STATE OF NEW YORK
PUBLIC SERVICE COMMISSION

**In the Matter of a Review of the Long-Term Gas
System Plan of Consolidated Edison and Orange and Rockland Utilities, Inc.**

Case 23-G-0147

Comments of
Natural Resources Defense Council,
with technical assistance and analysis from Synapse Energy Economics

Figure 1. Con Edison residential rates

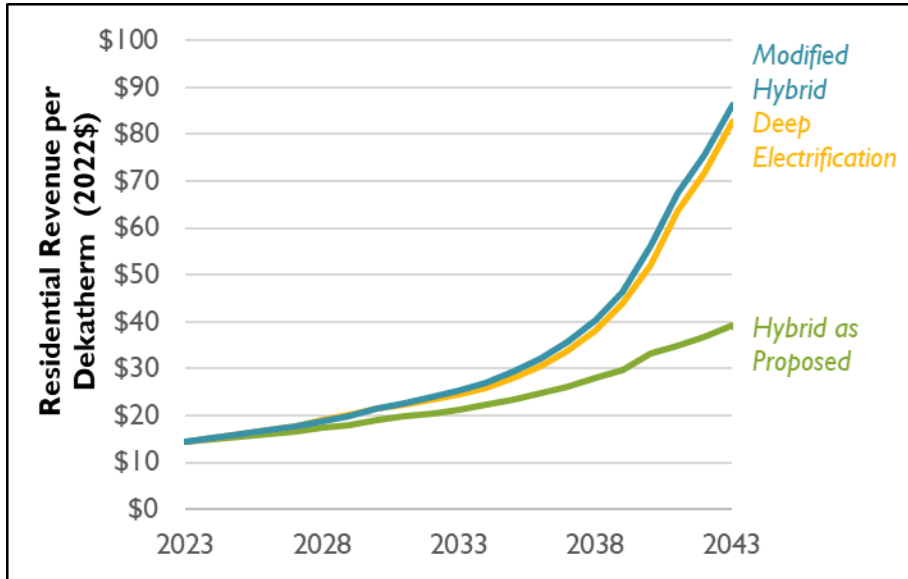
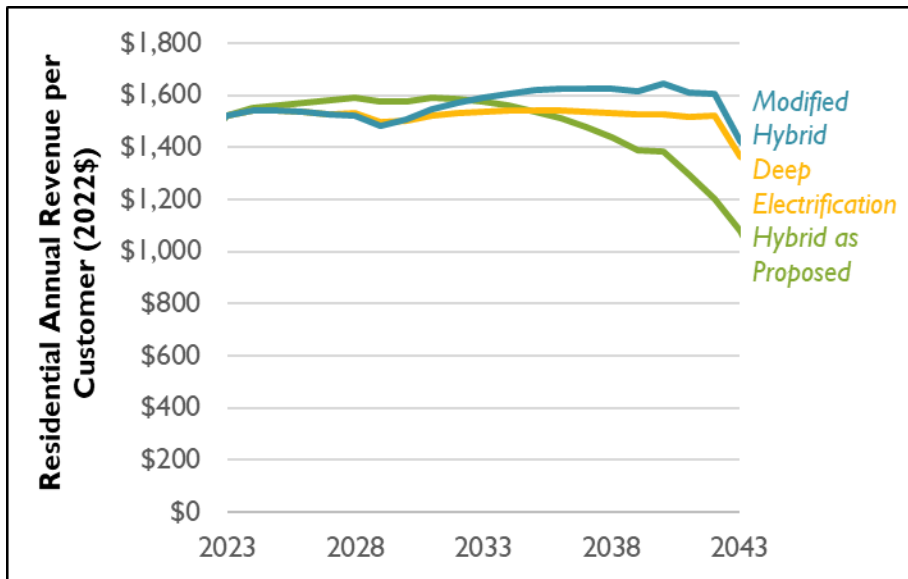
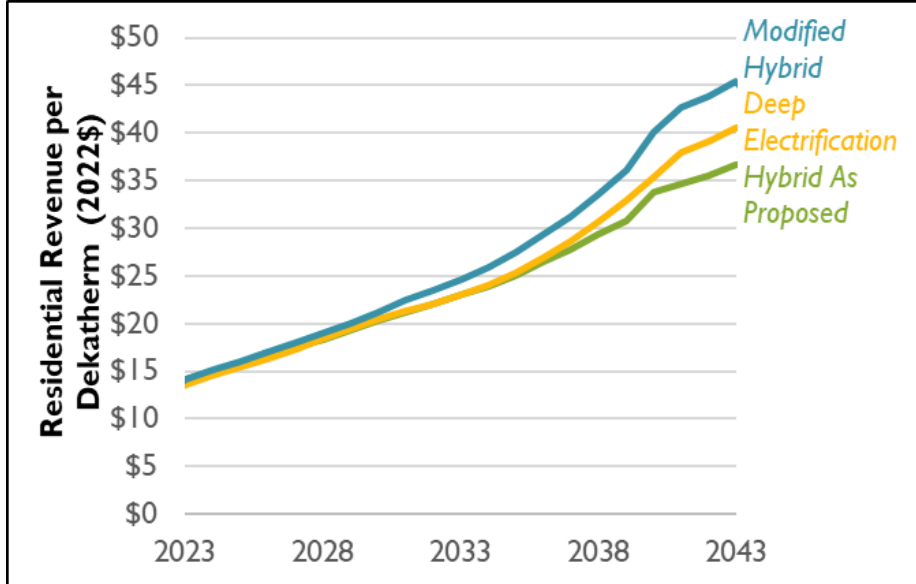
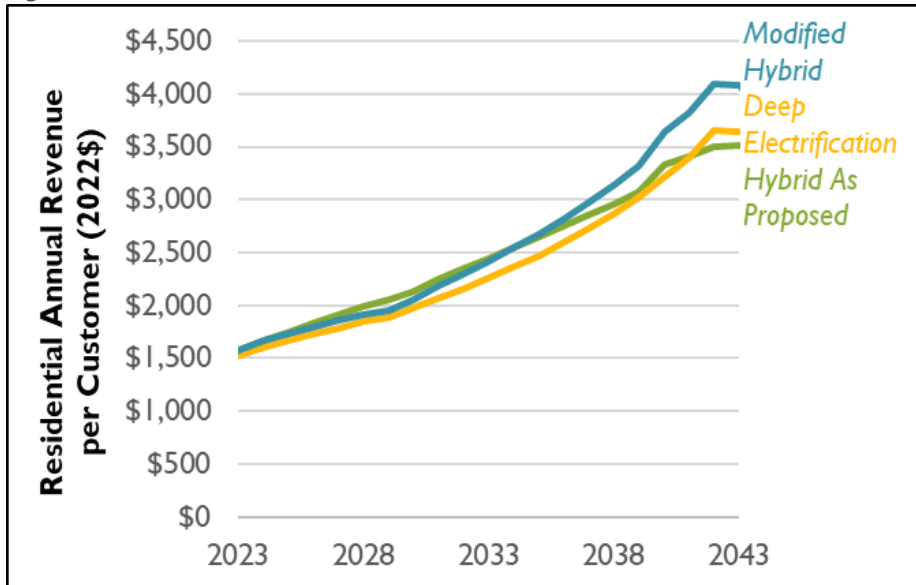
The modeling shows that the lower residential rates seen in the Hybrid As Proposed scenario are primarily due to continued high customer counts and throughput levels. This effect dilutes the impact of higher supply costs for LCFs, which otherwise push up rates for Hybrid As Proposed. The Modified Hybrid scenario assumes a decline in gas throughput as customers respond to high gas prices, brought on by continued gas system investment and incorporation of more expensive fuels. Those customers remaining on the system will see drastically increasing rates and bills, even higher than those under the Deep Electrification scenario. Figure 2 through Figure 5 present the projected rates and bills for each scenario and company.

Figure 5. Con Edison rate base

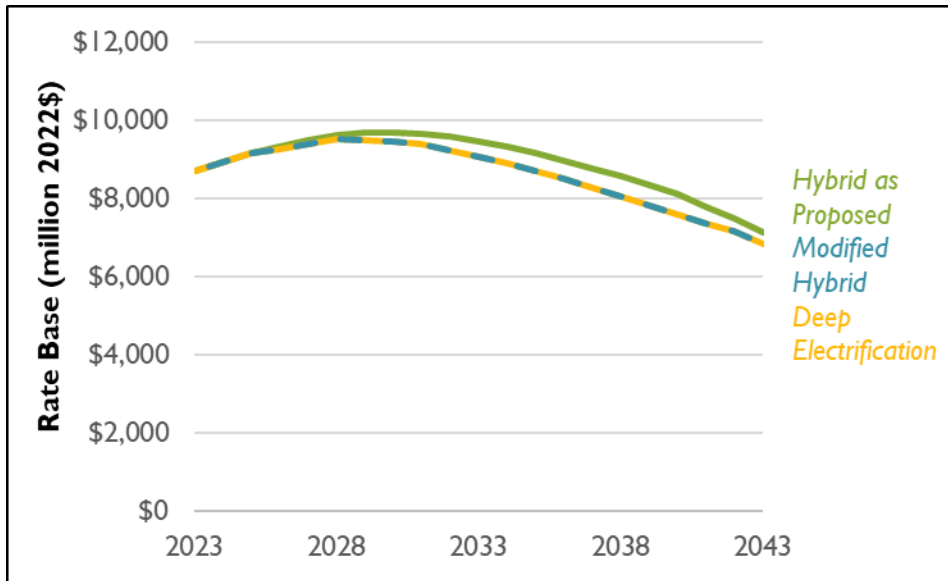
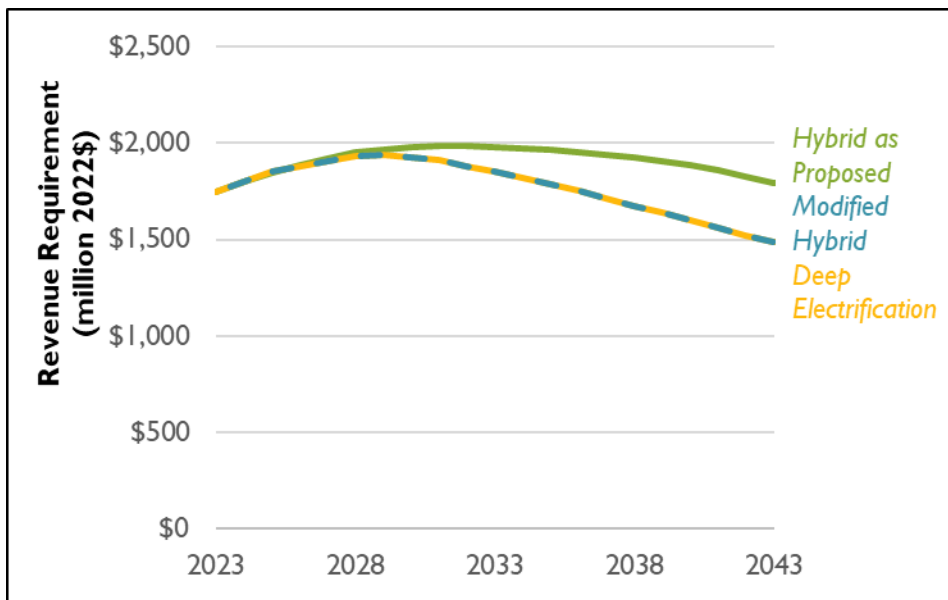
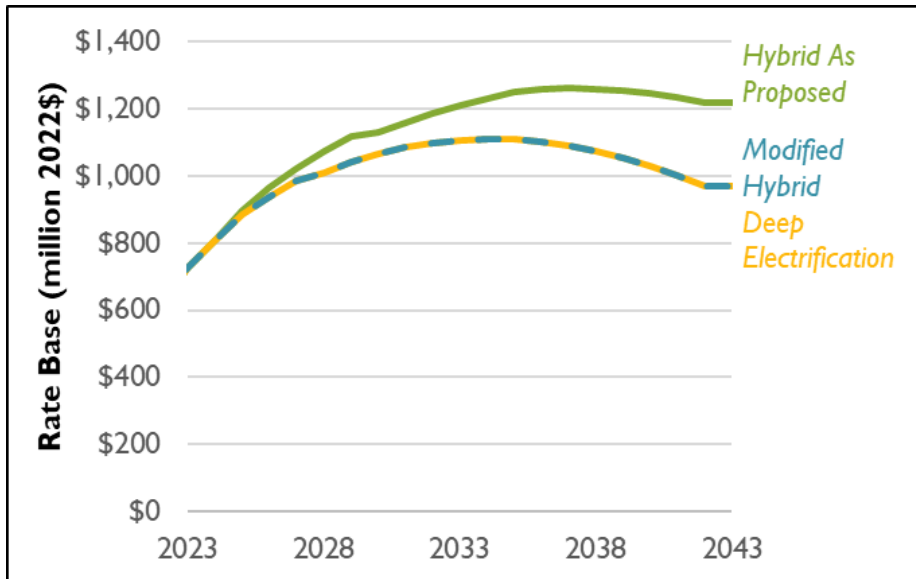
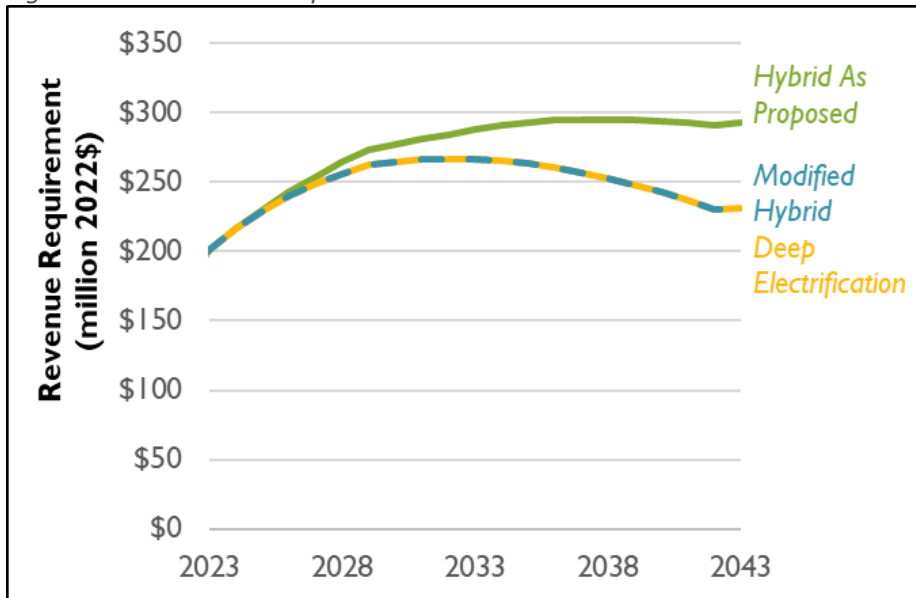
As shown in Figure 5 and Figure 7, comparison of the Hybrid As Proposed and the Modified Hybrid scenarios (which have the same investments as the Deep Electrification scenario and thus follow the same curve) shows the impact of shortening the MRP on rate base. Conversely, the increases in rate base in the Hybrid As Proposed scenario represent a larger balance that could be stranded in the future.
